Subject: **Bid No. 7800-W2, Coal Mine Brook Site Improvements / DPWP**

**ADDENDUM NO. 2**

**Date:** May 12, 2022  
**Project:** Coal Mine Brook Site Improvements  
City of Worcester Dept. of Public Works and Parks; Parks, Recreation and Cemetery Div.

## Standard Park Permanent Sign 4'x4'

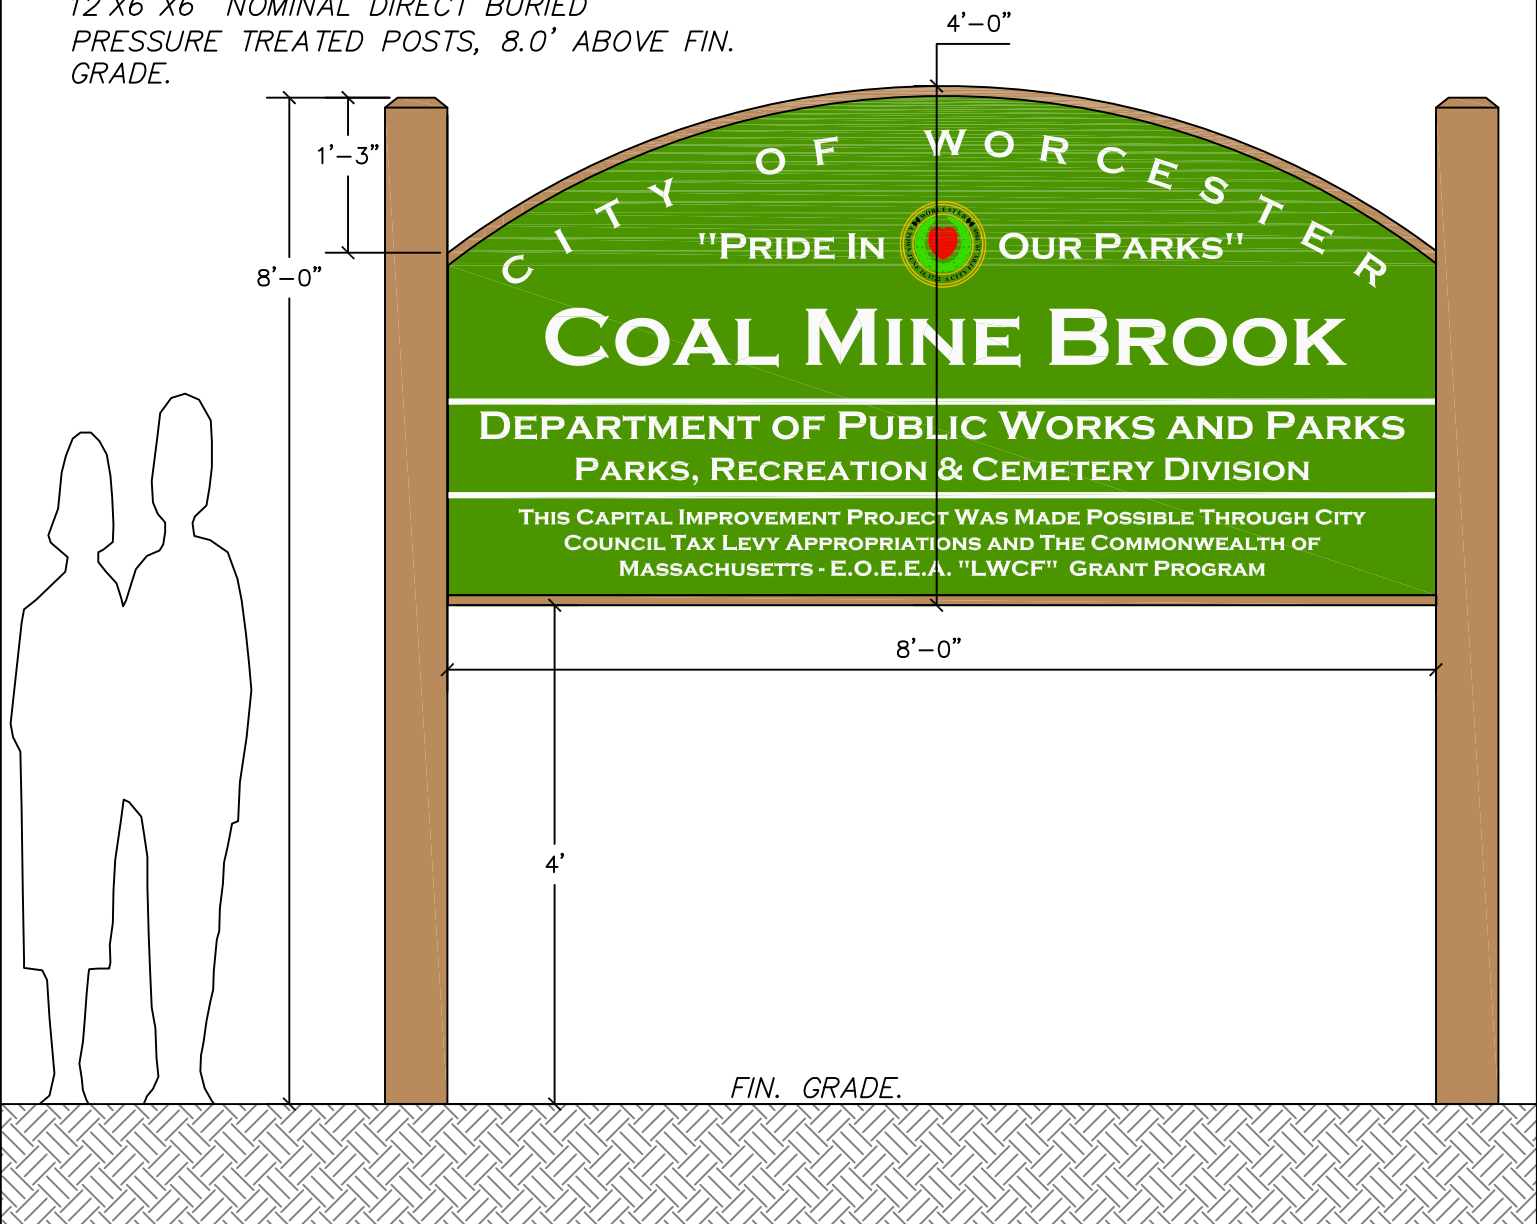
**Question1:** Who is responsible for the "Standard Park Signs"?  
**Answer:** **Contractor is responsible to furnish one 48"x48" and one 48"x96" Standard Park Sign as located by Ownwer. See Attachments.**

SIGN WILL BE 96"X48" SINGLE SIDED WITH  
1"X1" PVC PLASTIC PERIMETER PICTURE  
FRAME

3/4" MDO PLYWOOD, PRIMED AND PAINTED  
HUNTER GREEN, BOTH SIDES.

1/2" THICK WHITE PVC PLASTIC RAISED  
LETTERS – Park Title Only.

ALL LETTERING AND GRAPHICS ARE TO BE  
COMPUTER CUT WHITE VINYL.

FULL LEXAN SHIELD – 1/4" THICK

12'X6"X6" NOMINAL DIRECT BURIED  
PRESSURE TREATED POSTS, 8.0' ABOVE FIN.  
GRADE.

# SKA-1 Add Aternate # 1 Limit of Work

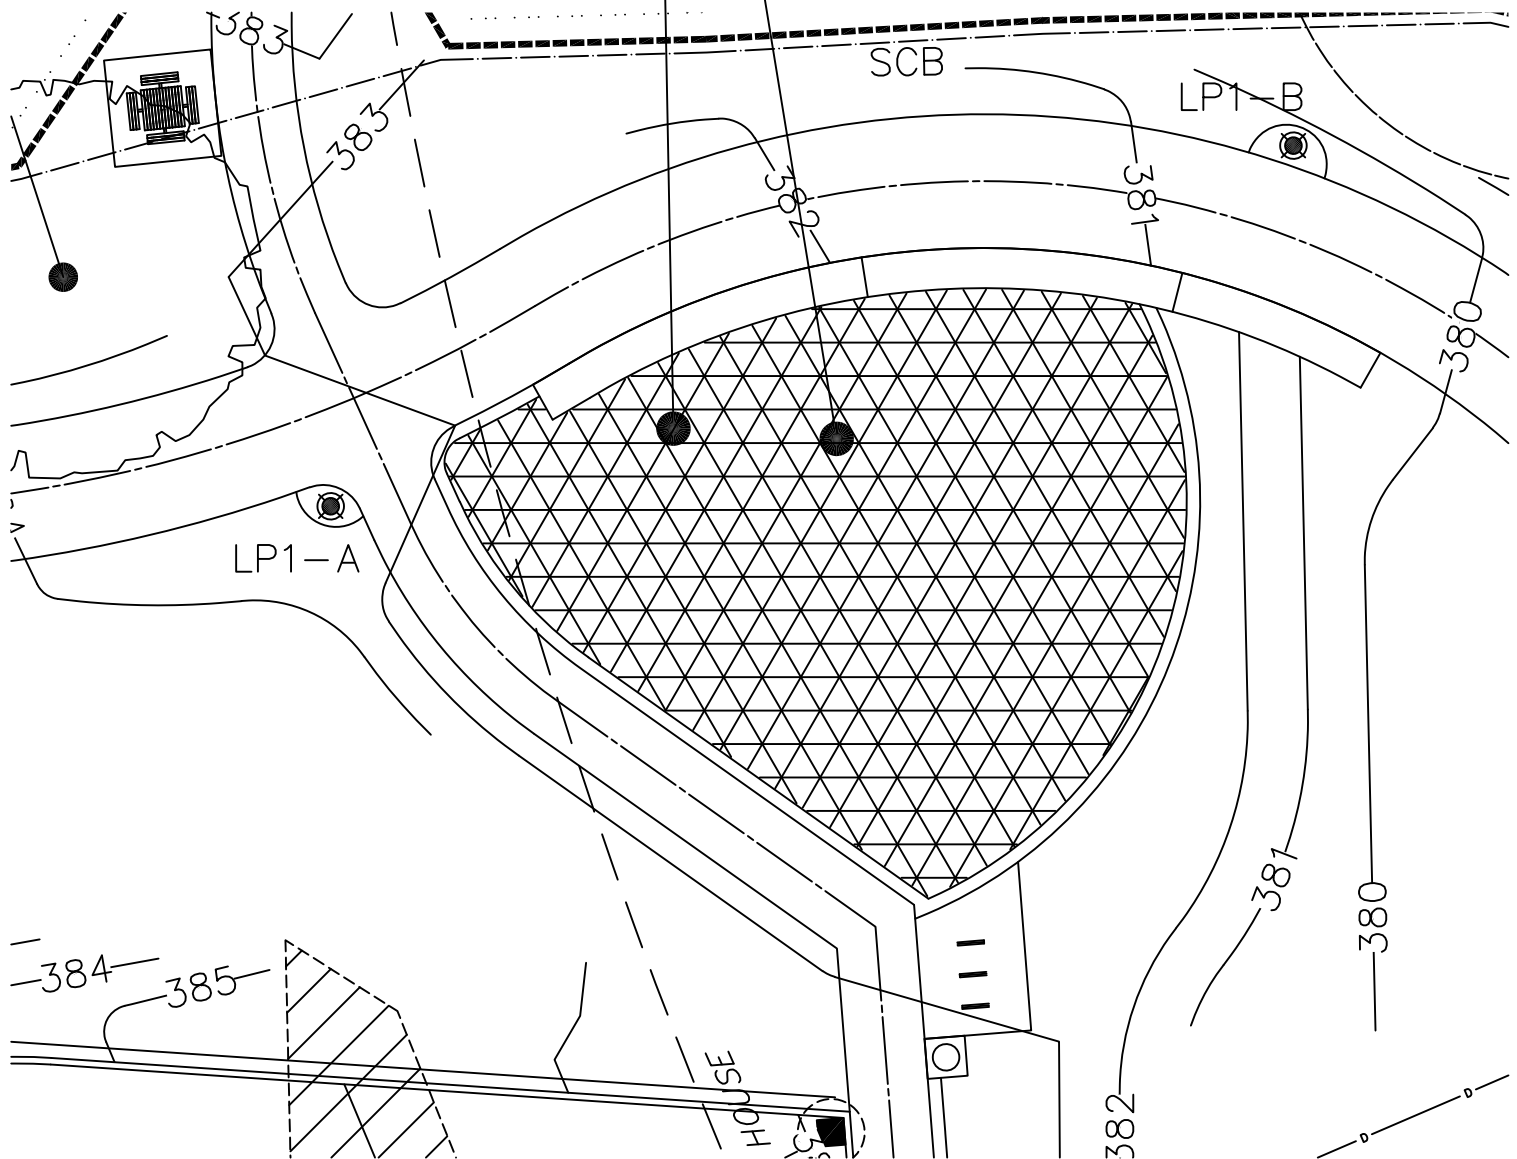
**Question2:** There is not a specification section describing the "Alternates". The work of the Alternates appears on the Bid Form. On the Lay-Out plan, the P.I.P Safety Surfacing is indicated to be "Alternate 1", and P.I.P. Safety Surfacing for the playground equipment is indicated to be "Alternate 2". Are the "Precast Concrete Curbs to be included in the alternates? Are the "Concrete Pads" for the picnic tables and benches to be included in the alternates? Please clarify.

**Answer:** **Refer to SKA-1 and SKA-2.**

Base Bid; Loam and Seed to limits of Hatch Area

Add Alternate #1 ;  
With in Limits of hatched Area, furnish and  
install Outdoor Fitness Equipment,  
Subgrade, Required Reinforced Concrete  
Pad, Safety Surfacing and Site Furnishings.  
Refer to Article, 39, 40 and 43 of Project  
Special Conditions and Bid Drawings.
